**ADDENDUM NO. 5  
NEW WATER TREATMENT PLANT CLARIFIER  
PROJECT NO. 24-01**

**February 21, 2024**

TOWN OF EMMITSBURG, MARYLAND  
WATER PLANT CLARIFIER  
CIP NO: 4-1600-40-160-1

**ADDENDUM No. 5**  
FEBRUARY 20, 2024

**D** CONCRETE WALK DETAIL  
C-03 SCALE: NOT TO SCALE

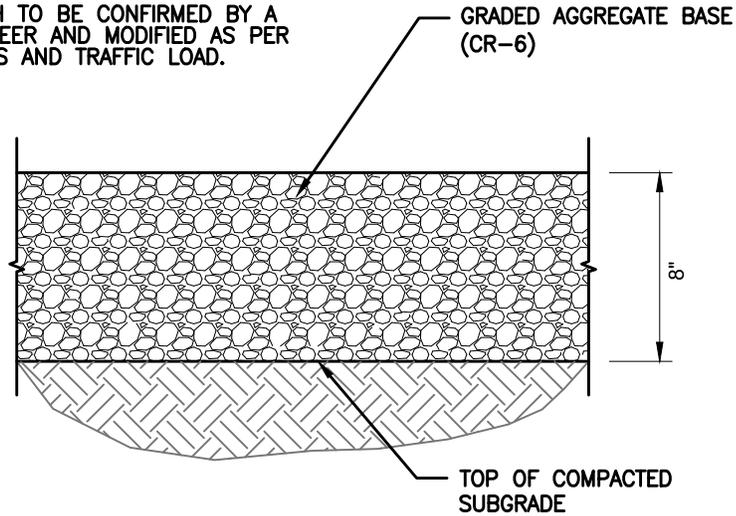
9. Please provide details for the 4' wide concrete sidewalk on the site.

**Response:** *A detail for the 4-foot wide concrete sidewalk is attached with this addendum.*

1. DISTANCE BETWEEN CONTROL JOINTS SHALL BE EQUAL TO WIDTH OF SIDEWALK UNLESS OTHERWISE NOTED.
2. INSTALL EXPANSIONS JOINTS IN LIEU OF EVERY 4th CONTROL JOINT AND WHERE CONCRETE ABUTS OTHER RIGID PAVING OR STRUCTURES.

**C** VEHICULAR GRAVEL PAVING DETAIL  
C-03 SCALE: NOT TO SCALE

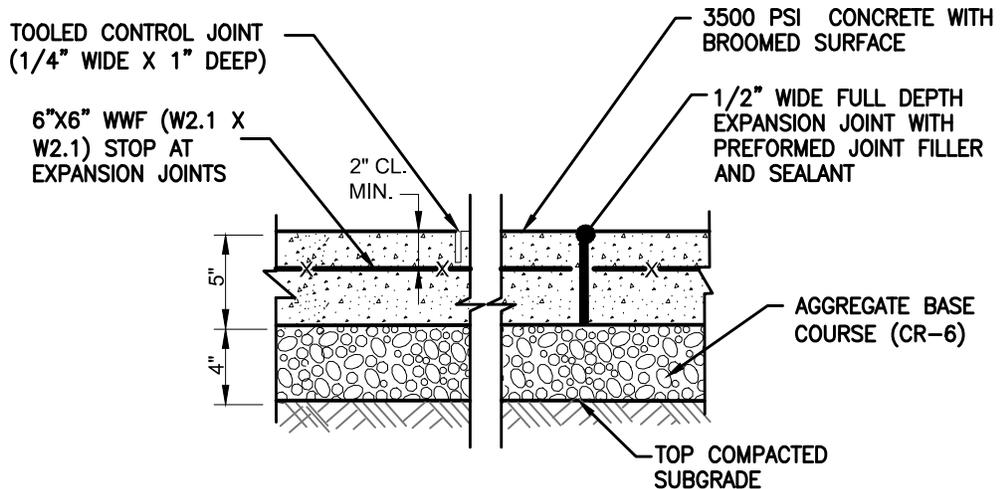
11. Please provide a detail / thickness for the new gravel lot as shown on drawing C-03.

16. Can a detail be provided for the proposed gravel lot?

**Response:** *A detail for the new gravel parking lot is attached with this addendum, see attached.*

NOTE:  
GRAVEL LAYER DEPTH TO BE CONFIRMED BY A  
GEOCHEMICAL ENGINEER AND MODIFIED AS PER  
SITE SOIL CONDITIONS AND TRAFFIC LOAD.
